**Fitzroy to Gladstone Pipeline – Aldoga Reservoirs SDA Approval (AP2022/003) – Minor Amendment**

The following information has been provided to support a minor change to the Aldoga Reservoirs State Development Area (SDA) Approval.

The Aldoga Reservoirs SDA approval was received on 30 August 2022, and since this time detailed design has progressed. As a result of the detailed design there have been minor modifications to the layout and the approved plans. These modifications are depicted in Attachment 1 – Updated Plans.

136 Goodnoon Street Gladstone Q 4680		PO Box 466 Gladstone Q 4680	Tel: (07) 4976 3000
FITZROY TO GLADSTONE PIPELINE PROJECT			
ALDOGA TANKS			
GENERAL			
OVERALL LAYOUT PLAN			
1151-DL06-STN-CIV-DRG-36004			
PROJECT No.	SIZE	DRAWING No.	SCALE
PF	A1	XXXX-X-XXXX	AS NOTED
			REV D

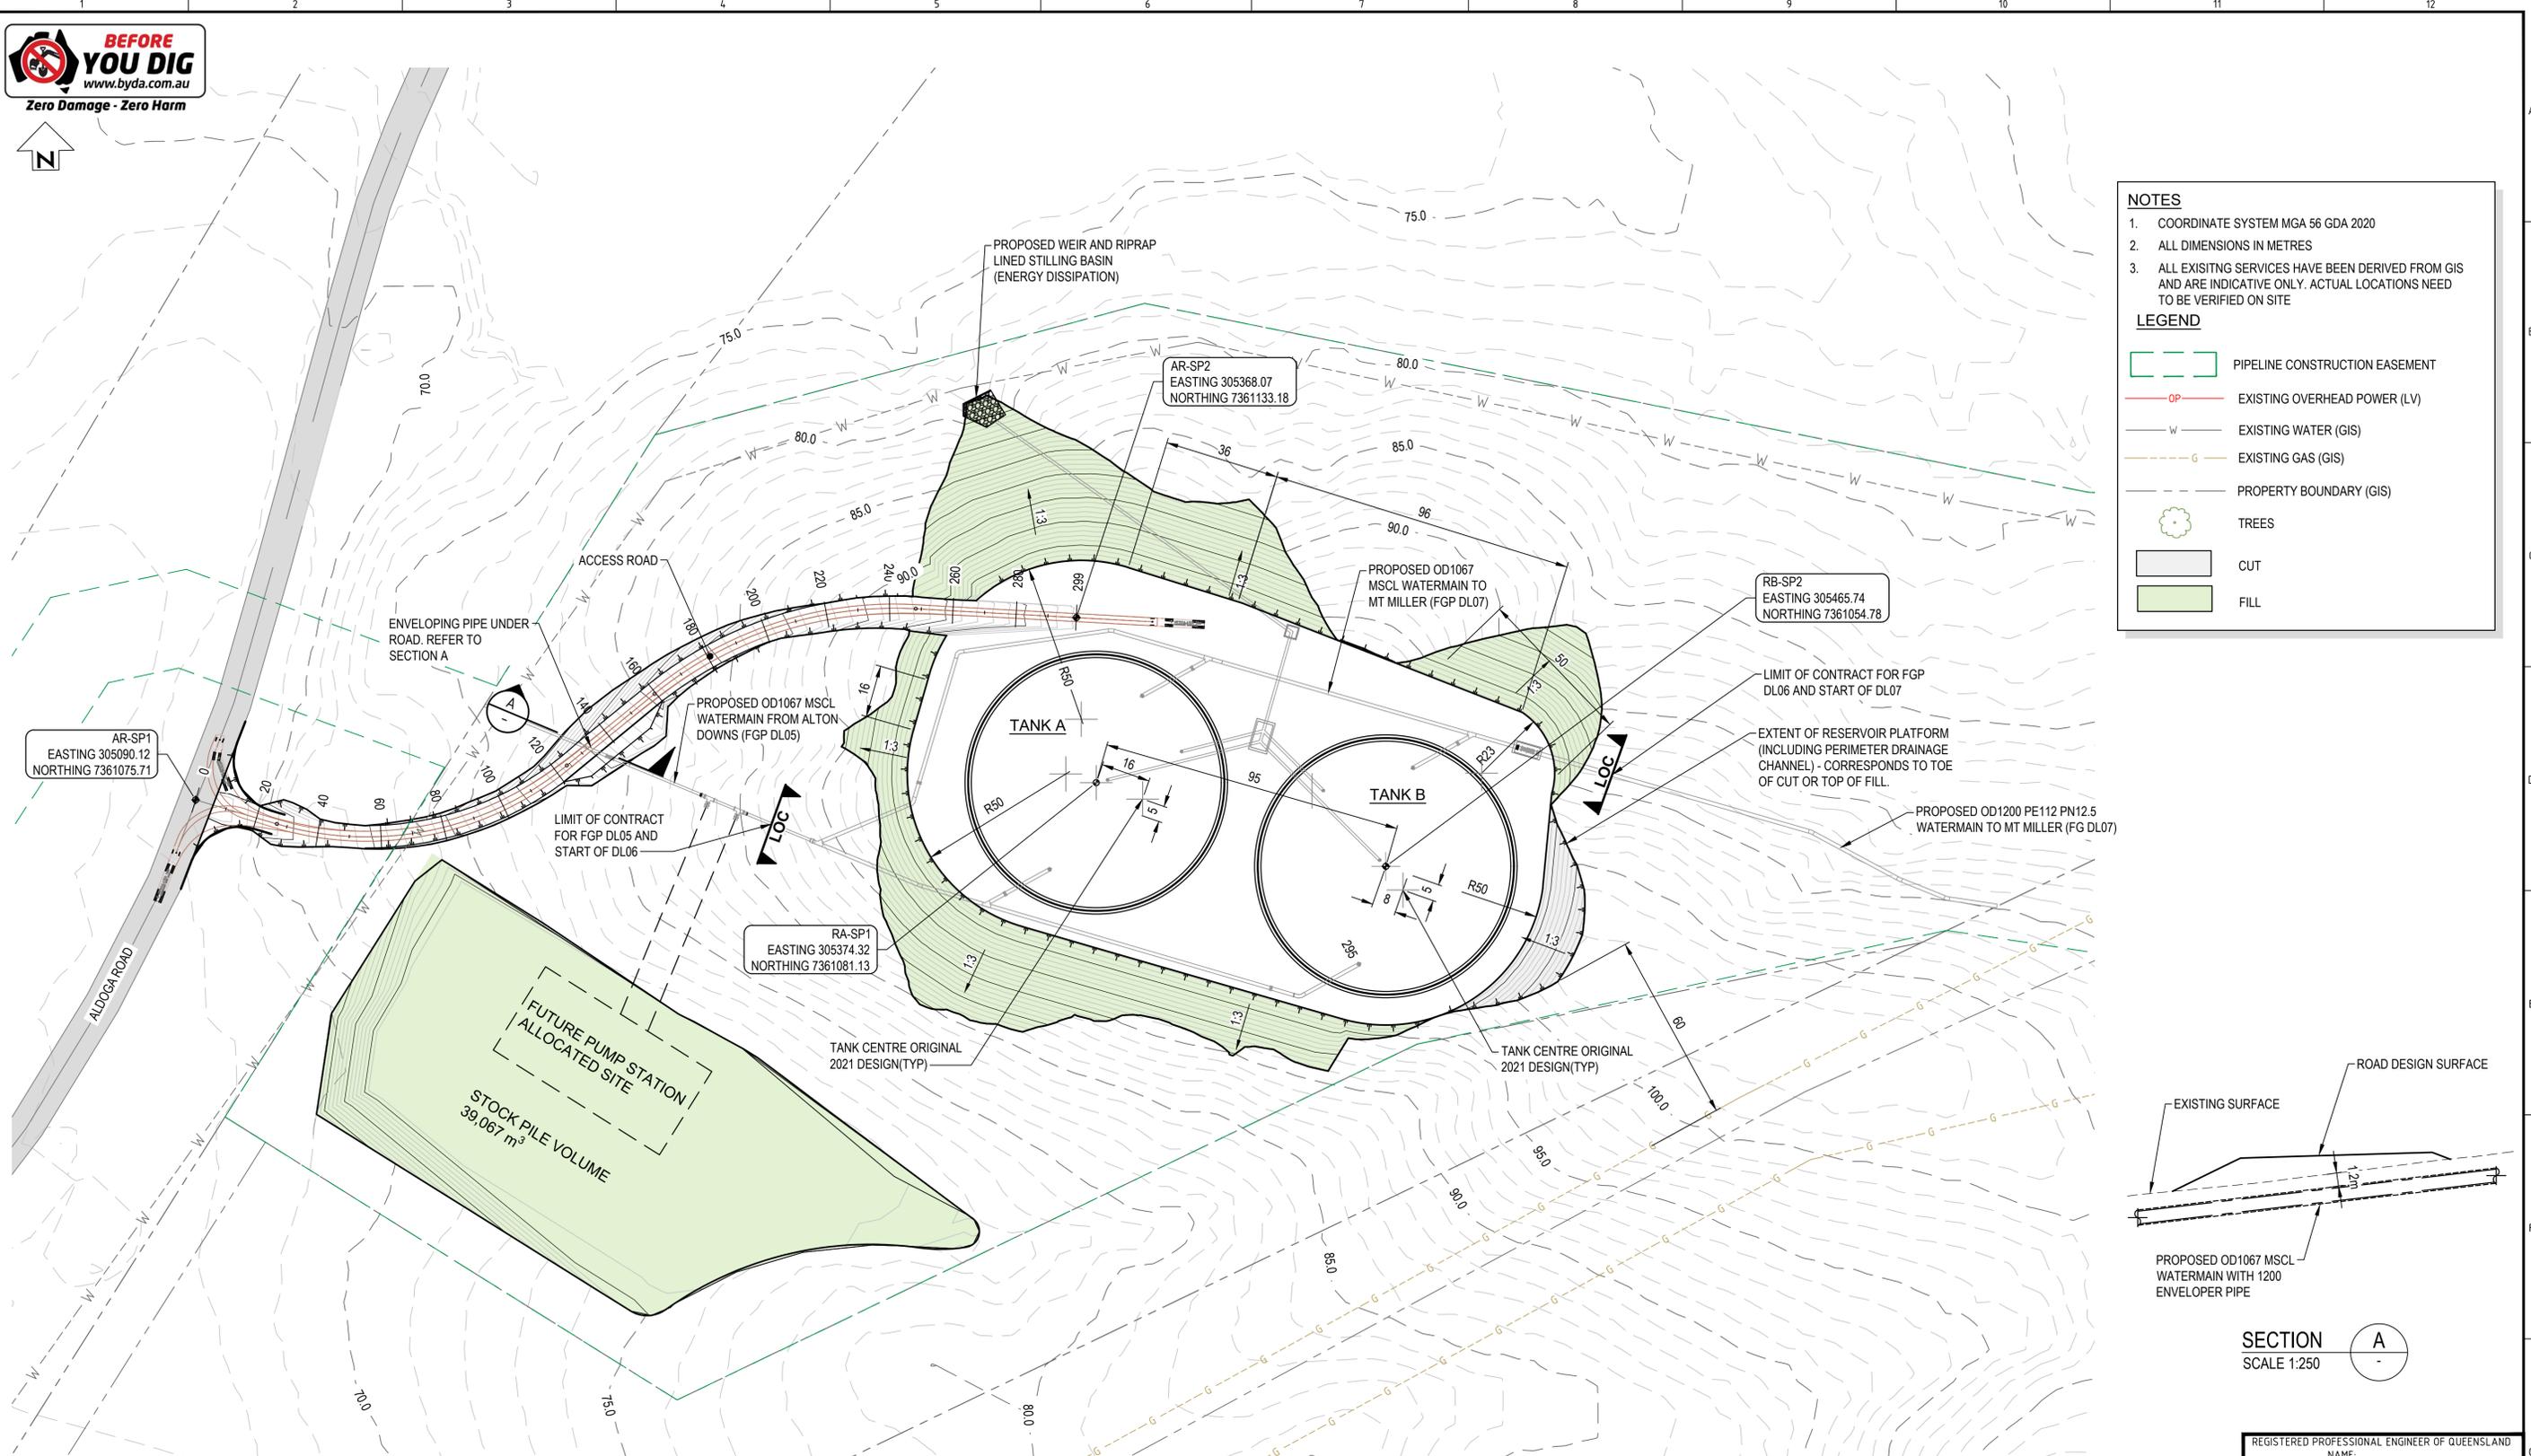
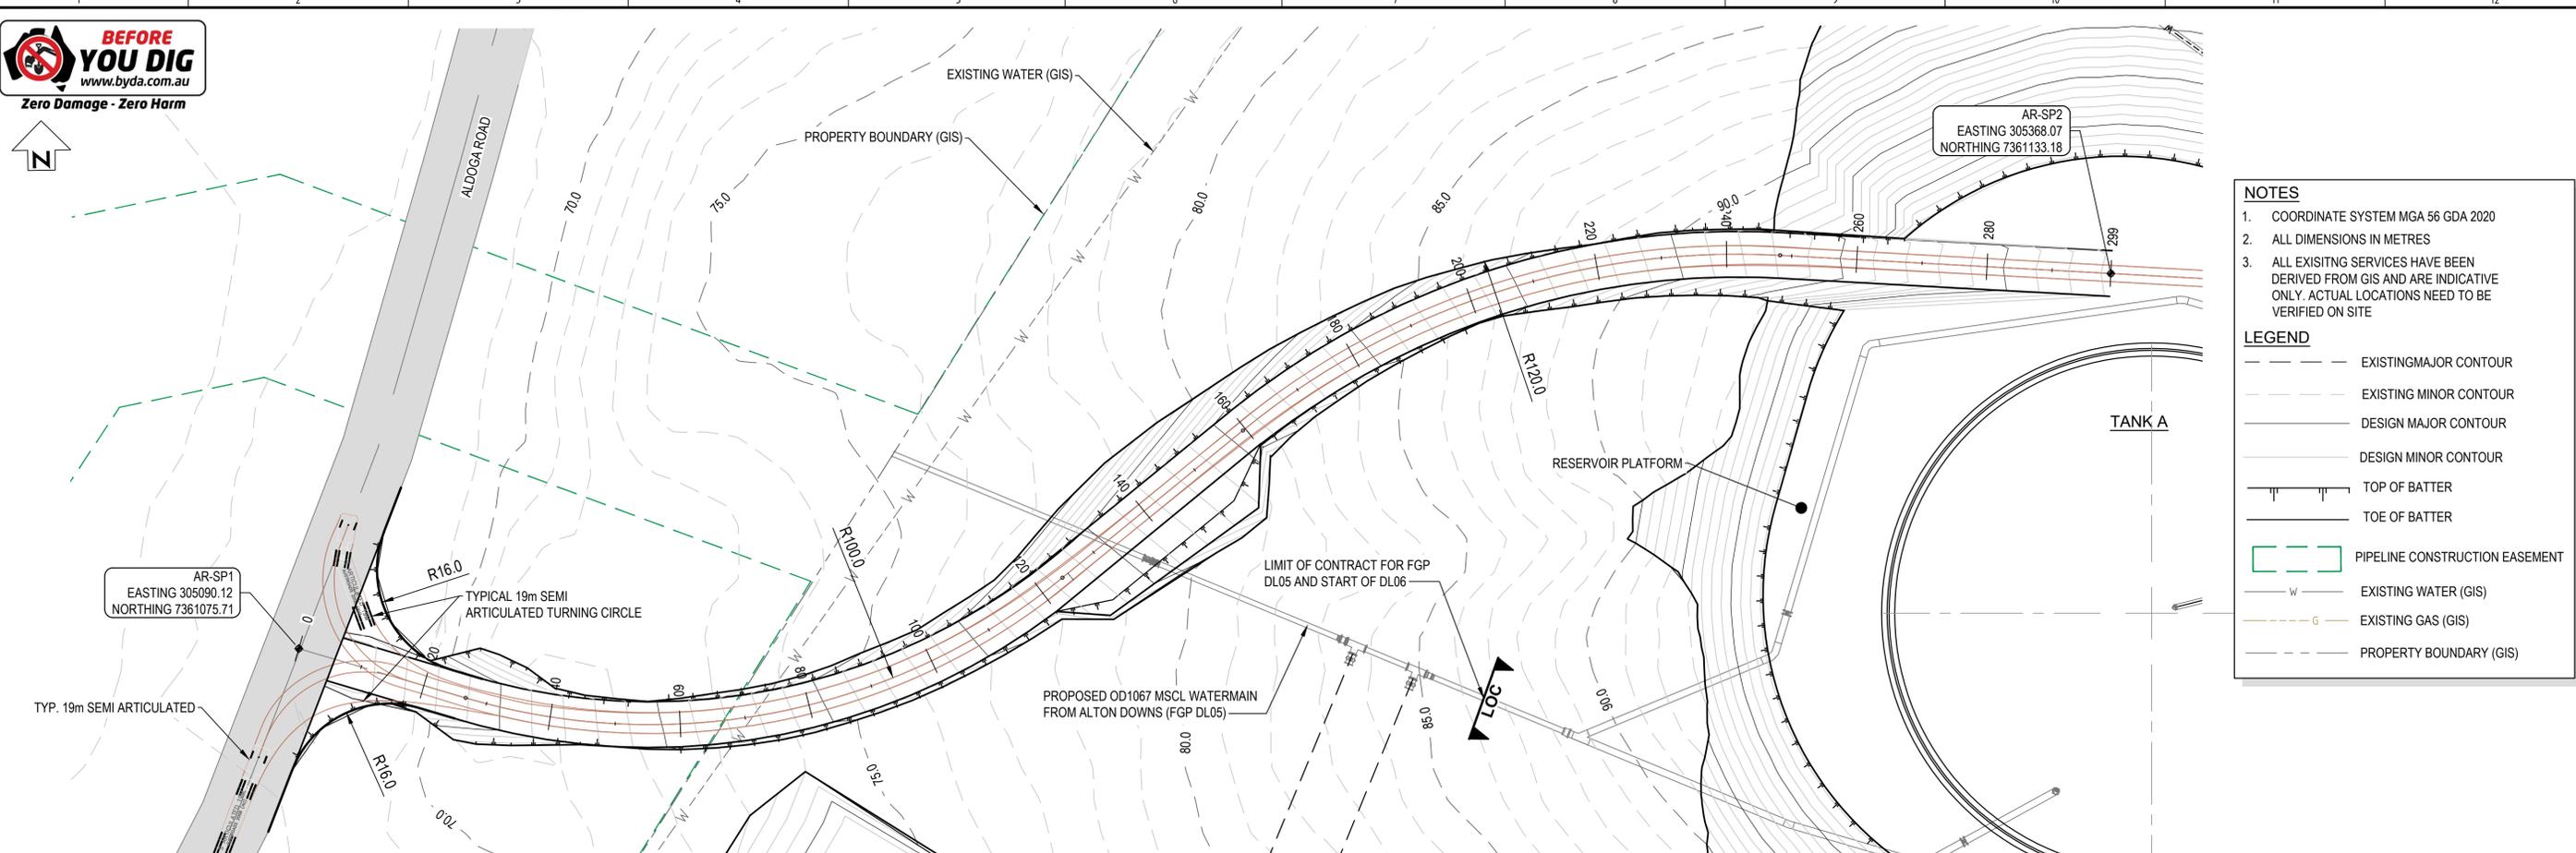
- Reservoir tanks' orientation – the concept design (as per the approved plans referenced in the current SDA approval) had the 2 x 50ML tanks partially located over cut in rock area and fill embankment, which would have caused a risk to the structures from differential settlement. The orientation change is required to fully locate the tanks on rock cut where settlement will not occur and cause cracking in tanks. There is no change in the assets / infrastructure in this GAWB-owned land, just a rotation of what was already planned and hence should be considered a minor change to the SDA Approval.

In addition, an emergency overflow pipeline location has been identified (refer to 1151-DL06-STN-CIV-DRG-36004, Rev D dated 23/06/2023), it was referred to in Table 5.3: Indicative Construction Timeline in the Planning Report dated 12 May 2022. The likelihood of an emergency overflow is very low and would only occur if the following combination of events were to occur, which is considered to be exceptionally unlikely:

- Table 1 of Condition 1.1 to be amended as per the attached plans (refer to Table 2 and Attachment 1).

**FITZROY TO GLADSTONE PIPELINE PROJECT**  
ALDOGA TANKS  
LAYOUT PLAN  
ROADWORKS  
1151-DL06-STN-CIV-DRG-36006

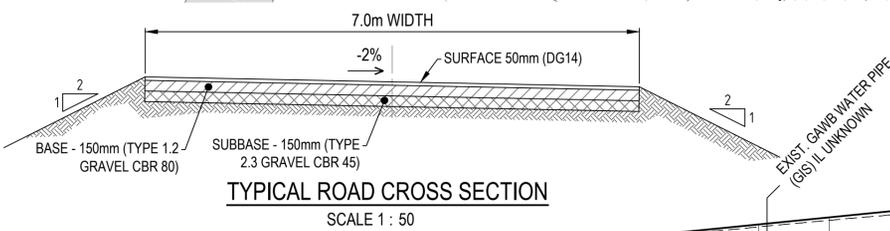
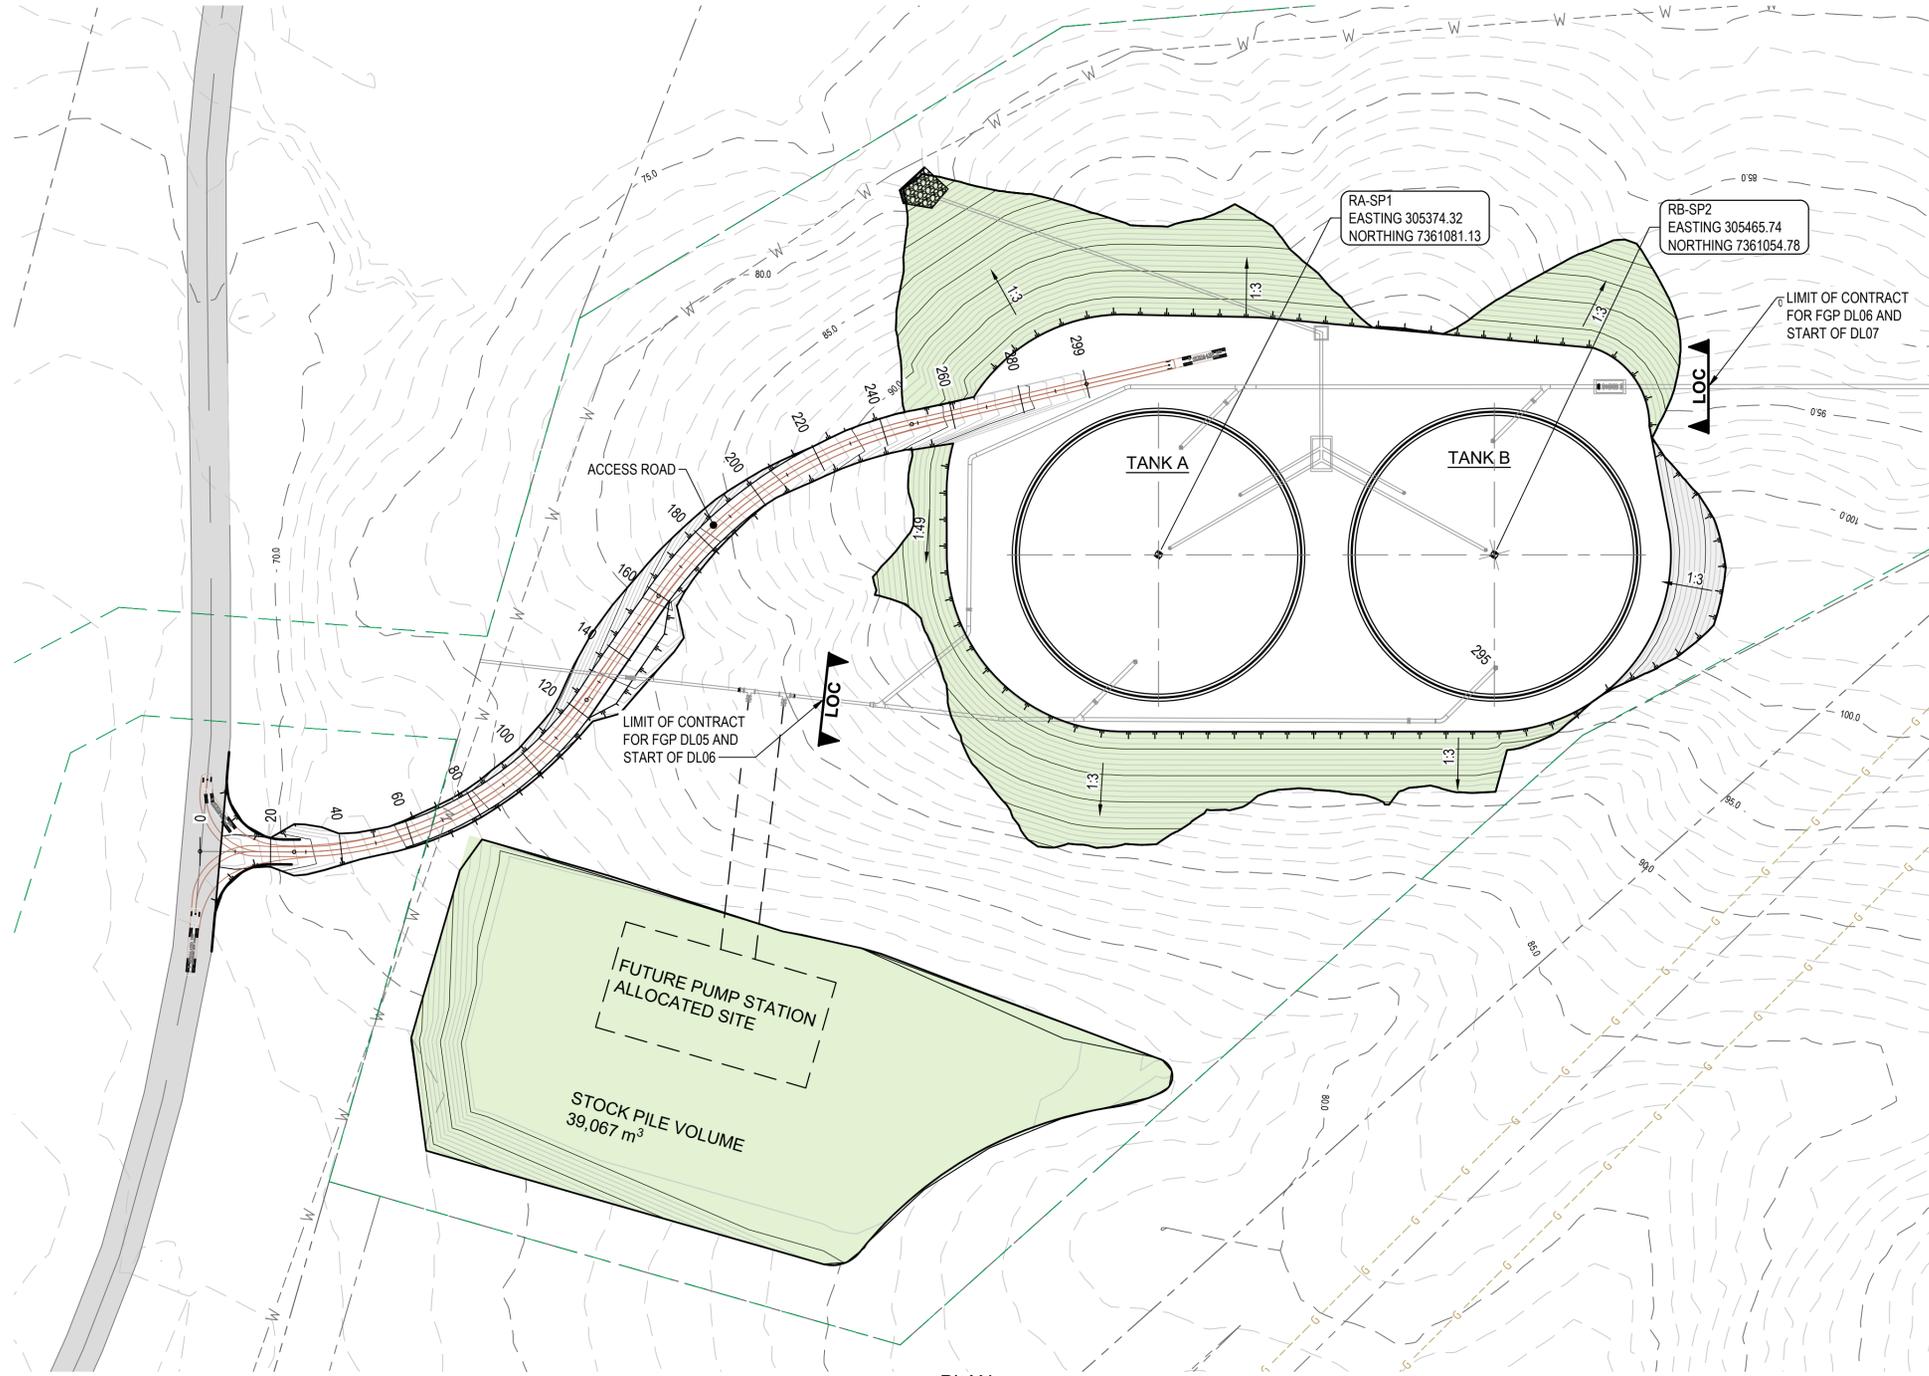
- Driveway and access road – slightly realigned based on feedback from GRC (in line with requirements of SDA approval condition 12.4 and Advice), with concern expressed about the length / extent of the access road within the road corridor, and the angle of the driveway to Aldoga Road as depicted in the approved plan. The alignment has been revised and minimised to address the GRC concern; however, the elements and infrastructure of the approved plans have not changed, and it is considered should represent a minor change to the SDA Approval.

*Limit access to the site to via Aldoga Road as shown on the plan titled "Fitzroy to Gladstone Pipeline Project – **Aldoga Tanks Layout Plan Roadwork**" prepared by Stantec / MBJV (Plan number: **1151-DL06-STN-CIV-DRG-36006, Rev C**) dated **23/06/2023** in Table 1.*

- generally in accordance with the plan titled "Fitzroy to Gladstone Pipeline Project – **Aldoga Tanks Layout Plan Roadwork**" prepared by Stantec / MBJV (Plan number: **1151-DL06-STN-CIV-DRG-36006, Rev C**) dated **23/06/2023** in Table 1*
- in accordance with the Gladstone Regional Council's Standard Drawn Urban Commercial/Industrial Driveway (CMDG-R-042A) or as agreed with Gladstone Regional Council.*
